CONSTRUCTION PLAN FOR:

CONTRACT NUMBER 82-073-05

REHOBOTH AVENUE BRIDGE NO. 153

1-15-87 AS BUILT PLANS P.K. E.I.

CONSTRUCTION PLAN-REHOBOTH AVE.
℄ STA. 22+50 TO STA. EB 29+00

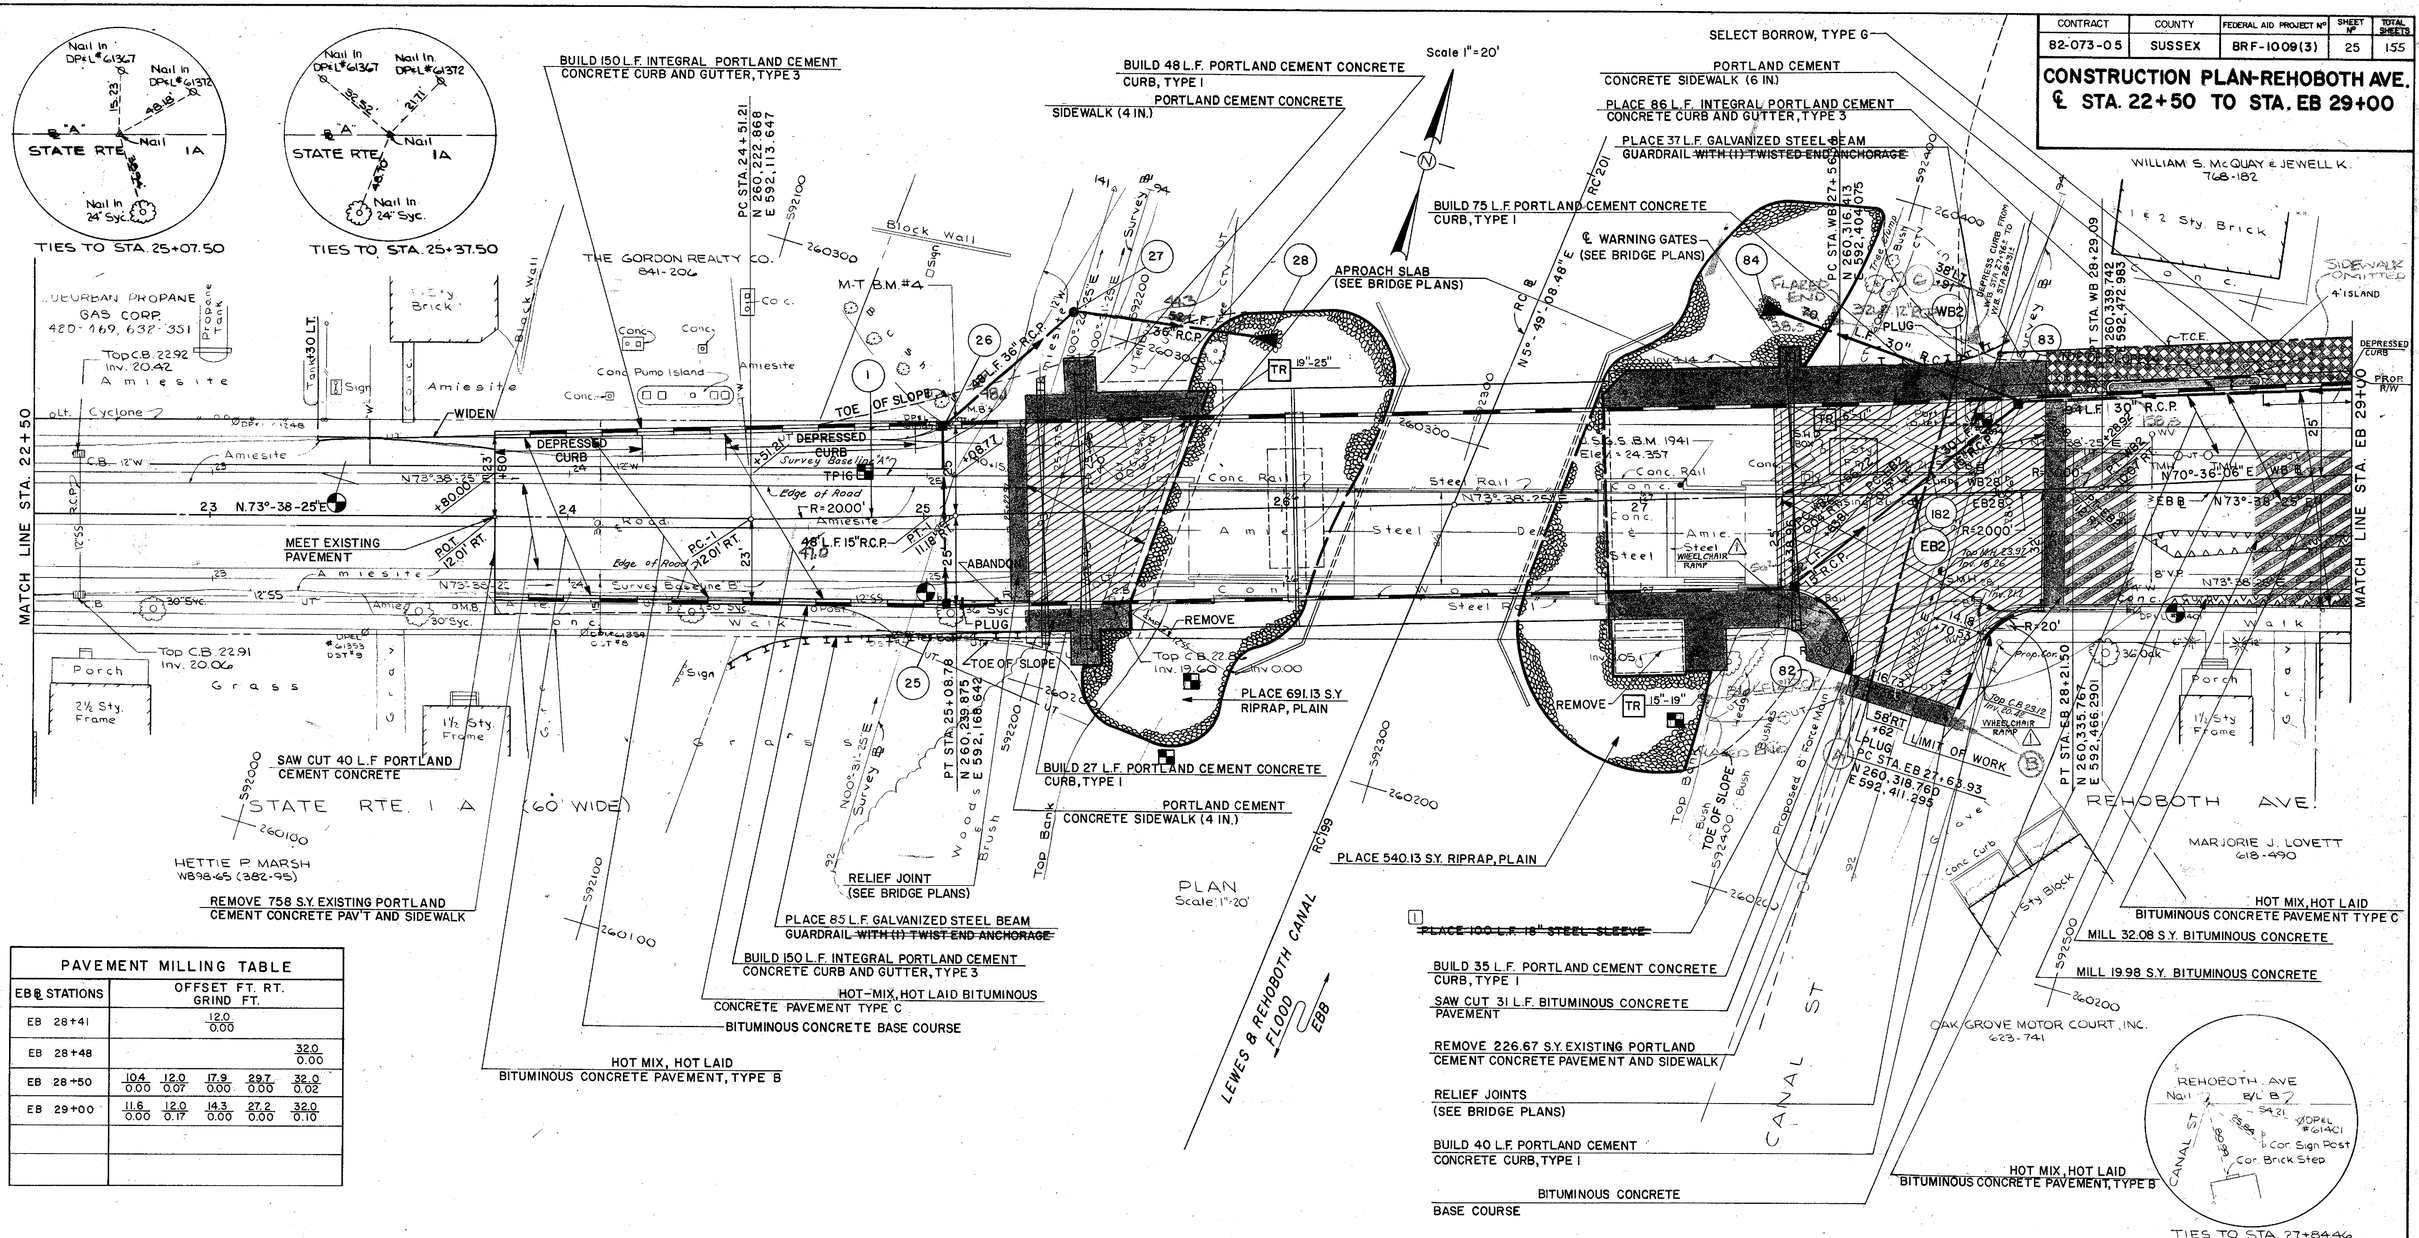
REVISIONS
△ ADDENDUM "Z" - ADDED WHEELCHAIR RAMPS JMSJr. 9/26/84
1 REVISION - DELETED STEEL SLEEVE 11/16/84 JMSJr.

CONSTRUCTION PLAN-REHOBOTH AVE.
℄ STA. 22+50 TO STA. EB 29+00

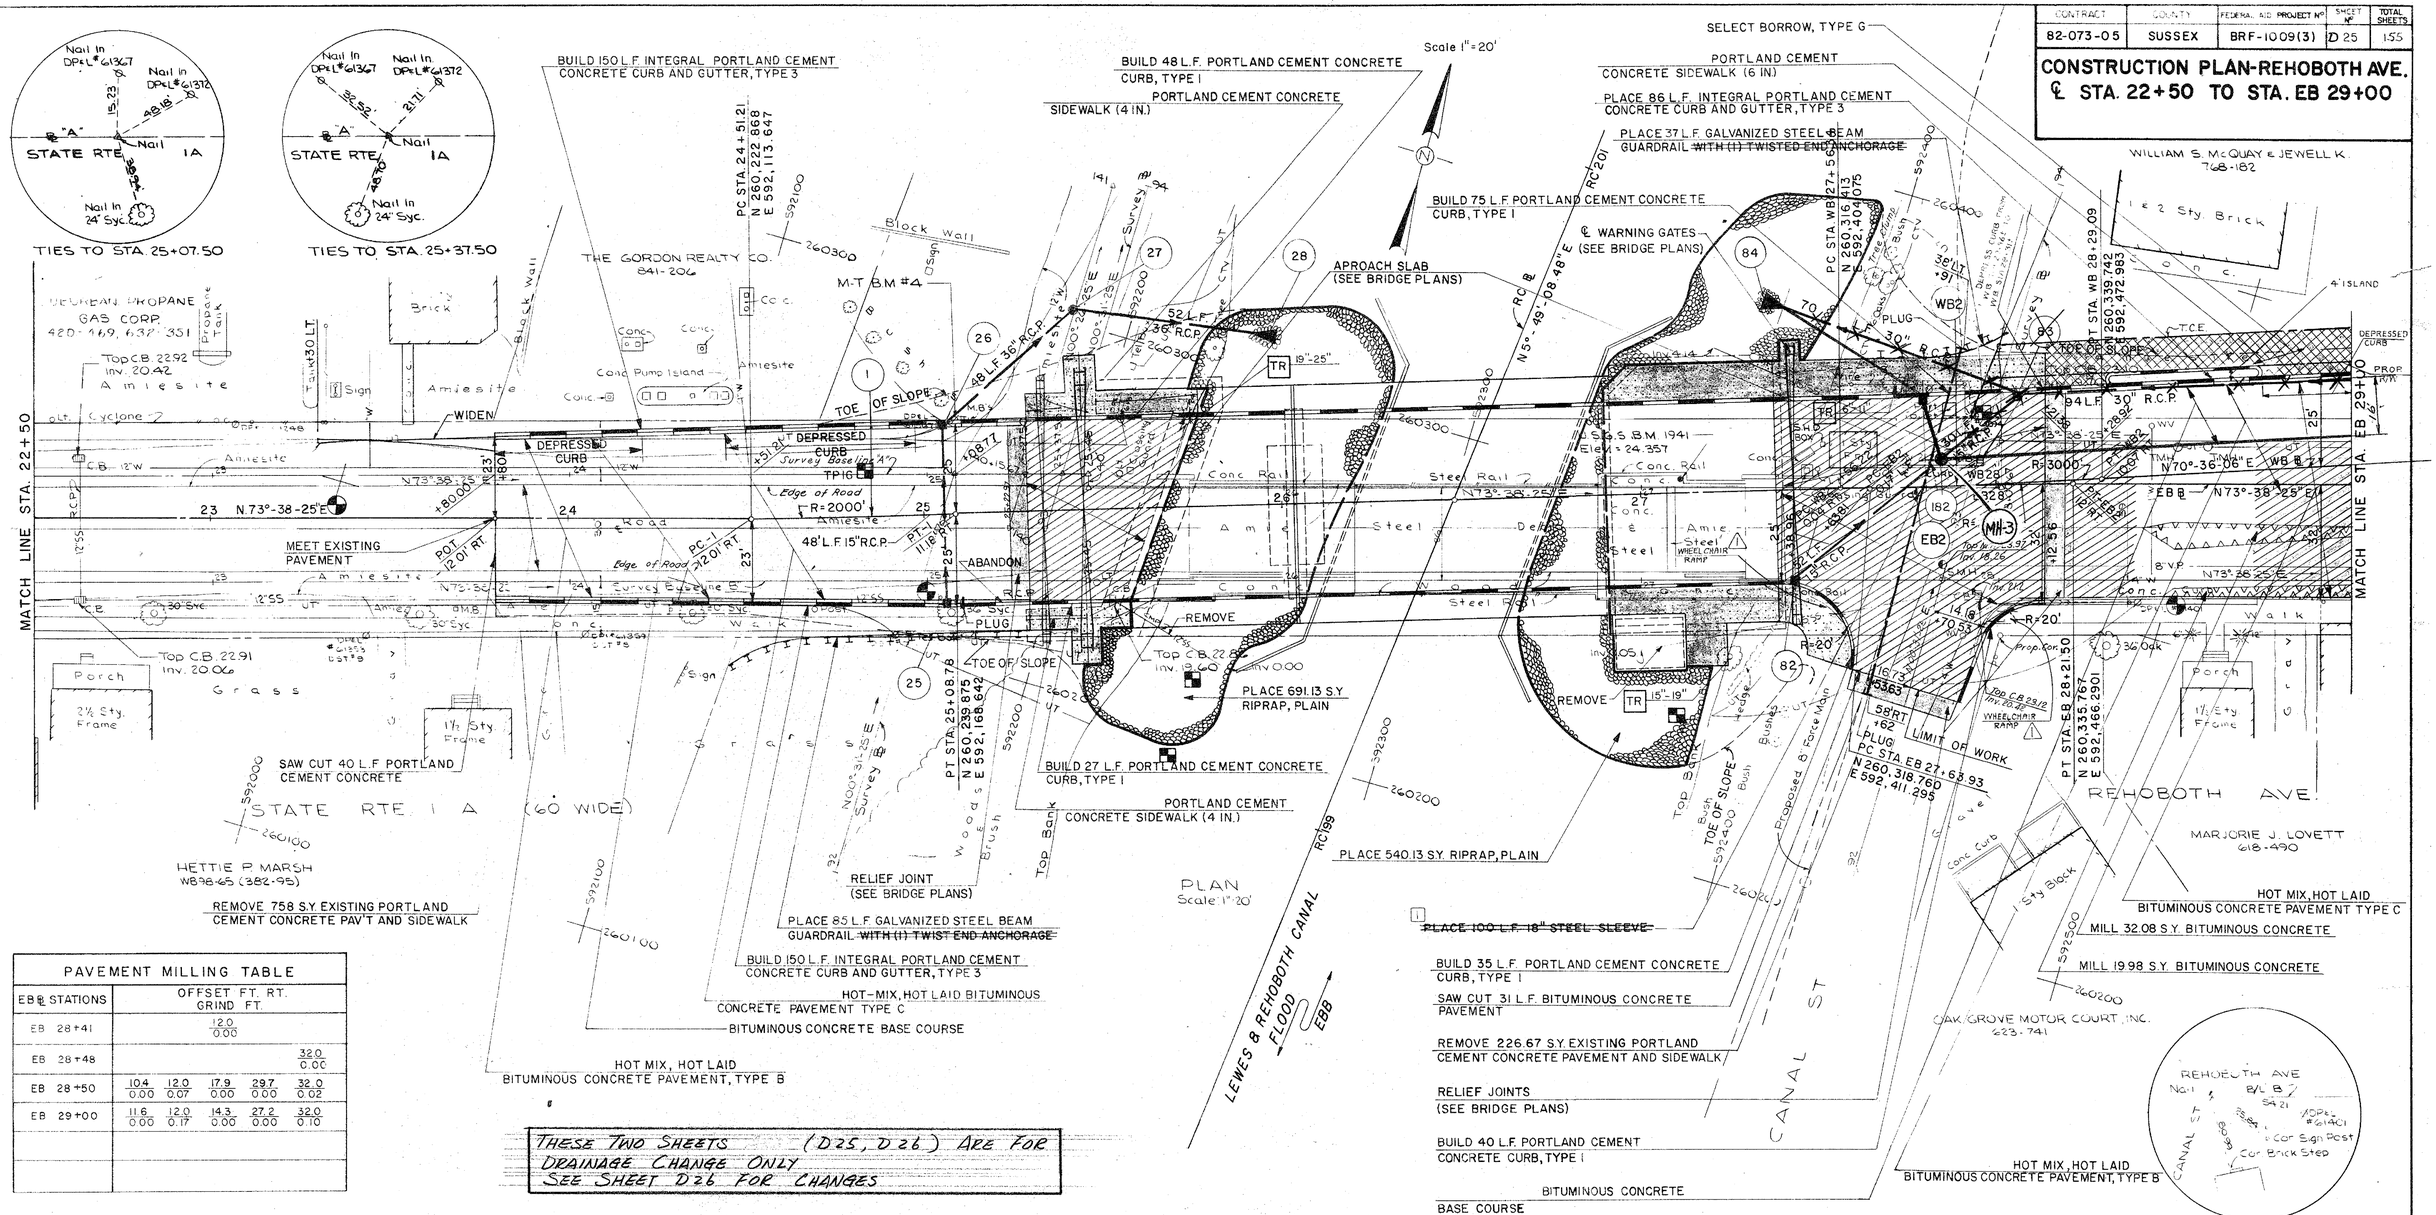
REVISIONS
1) ADDED HANDICAP RAMPS JM 9/24/84
2) REVISION - DELETED STEEL SLEEVE 11/5/84 JM

THESE TWO SHEETS (D25, D26) ARE FOR DRAINAGE CHANGE ONLY. SEE SHEET D26 FOR CHANGES

CONSTRUCTION PLAN-REHOBOTH AVE.

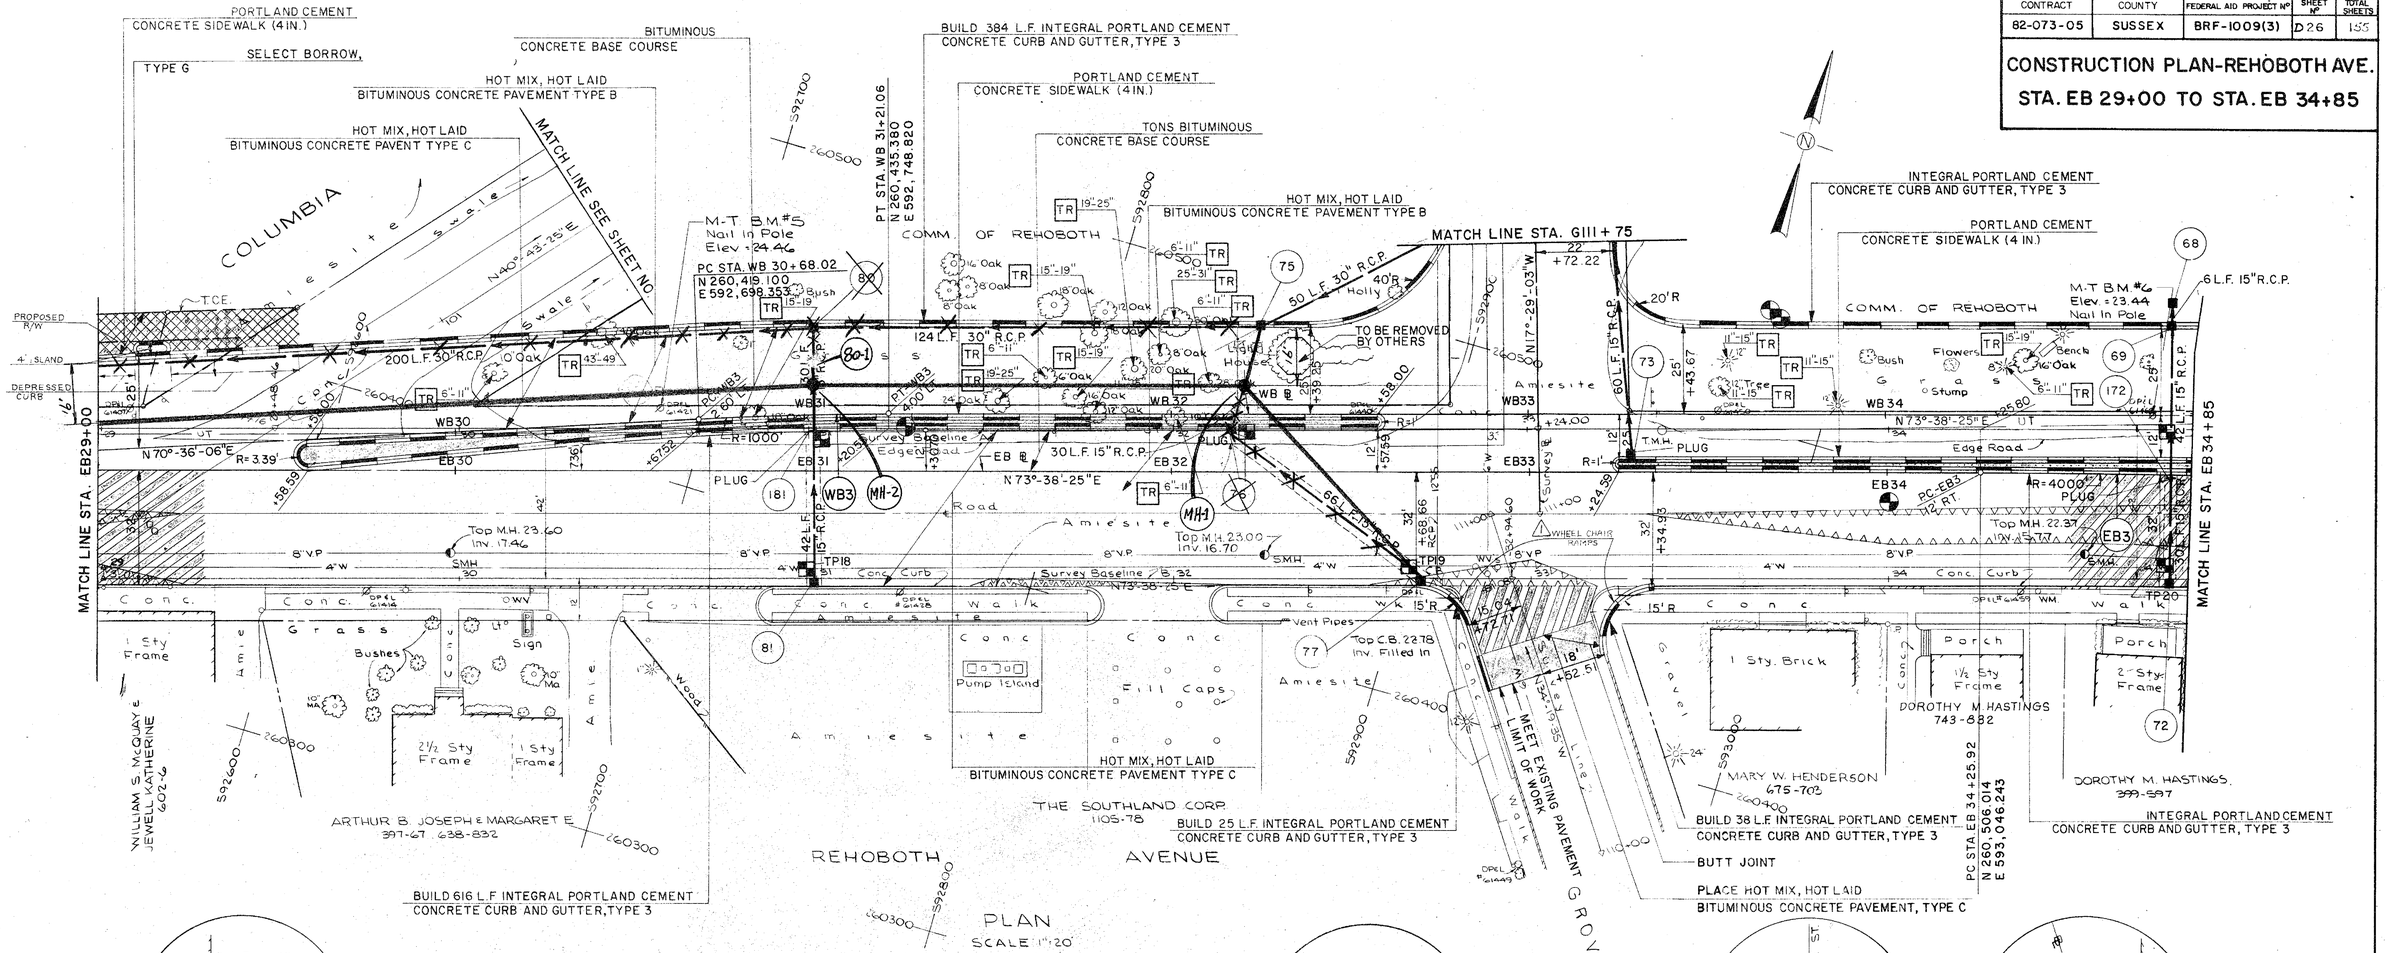
THESE TWO SHEETS (D25, D26) ARE FOR DRAINAGE CHANGE ONLY

C. ADD M.H.

D. ADD C.B.

NO.	MARK	TYPE	TOP EL.	INVERTS	STATION	OFFSET
1	83-1	J'MODIFIED	SET IN FIELD	11.23, 11.25	27+80	25' LT.

E. ADD PIPES

F. CHANGE FLARE END SECTION INVERTS

THESE TWO SHEETS (25R, 26R) ARE FOR DESIGN CHANGE ONLY

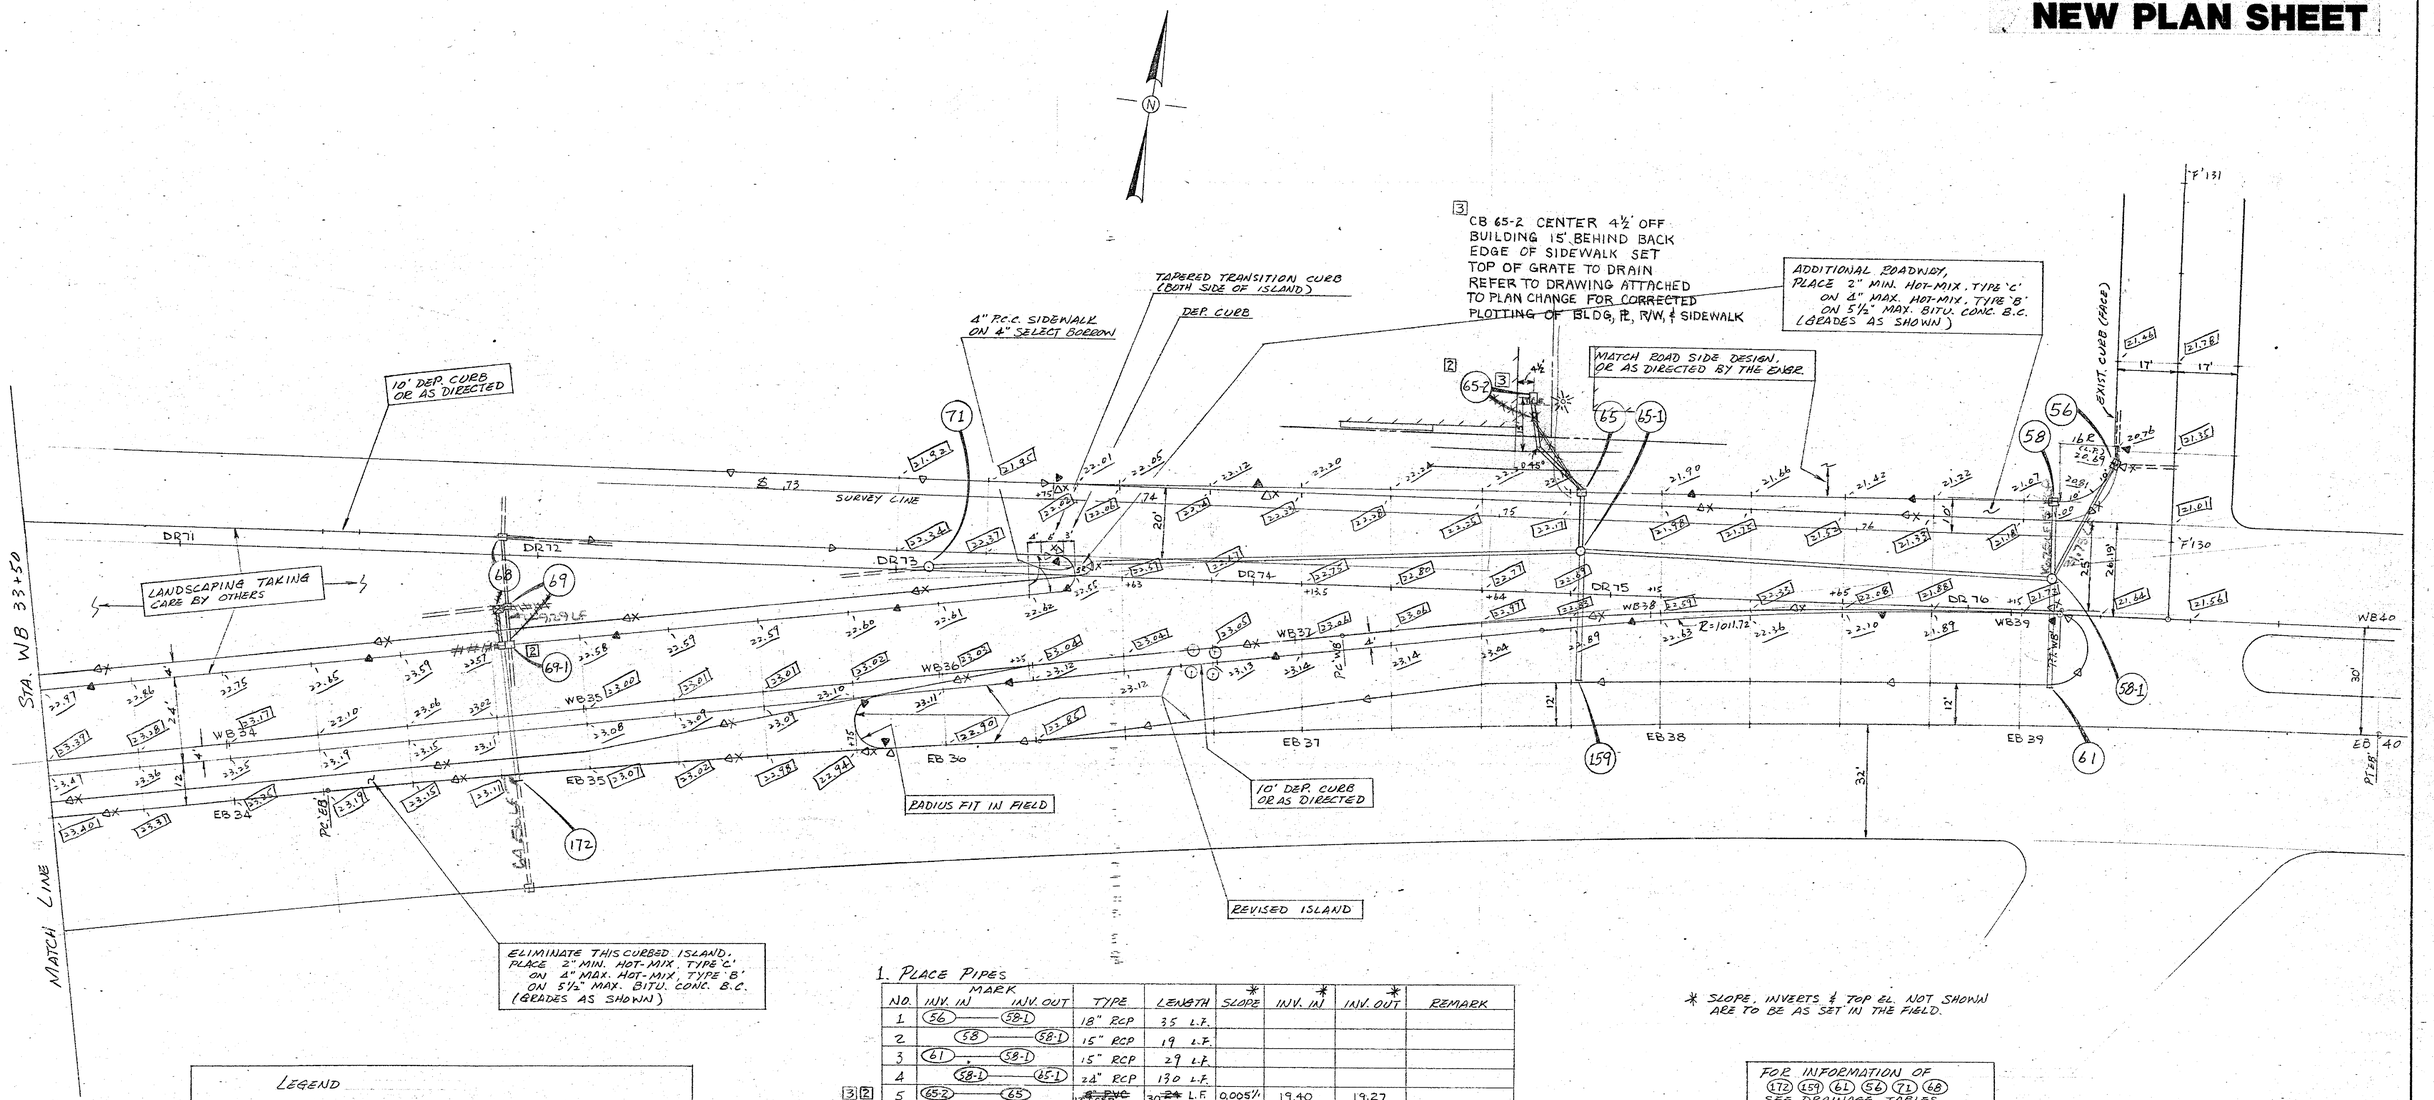
1. PLACE PIPES

NO.	MARK INV. IN	MARK INV. OUT	TYPE	LENGTH	SLOPE*	INV. IN*	INV. OUT*	REMARK
1	56	58-1	18" RCP	35 L.F.				
2	58	58-1	15" RCP	19 L.F.				
3	61	58-1	15" RCP	29 L.F.				
4	58-1	65-1	24" RCP	190 L.F.				
3 2 5	65-2	65	~~24" PVC~~ 12" RCP	30 ~~24~~ L.F.	0.005'/'	19.40	19.27	
6	65	65-1	15" RCP	14 L.F.				
7	159	65-1	15" RCP	35 L.F.				
8	65-1	71	24" RCP	180 L.F.

1. New plan sheet 4/25/85 JMS.Jr.
2. Added C.B. 65-2 & 69-1 7/2/85 JMS.Jr.
3. Changed location of C.B. 65-2 12/4/85 JMS.Jr.
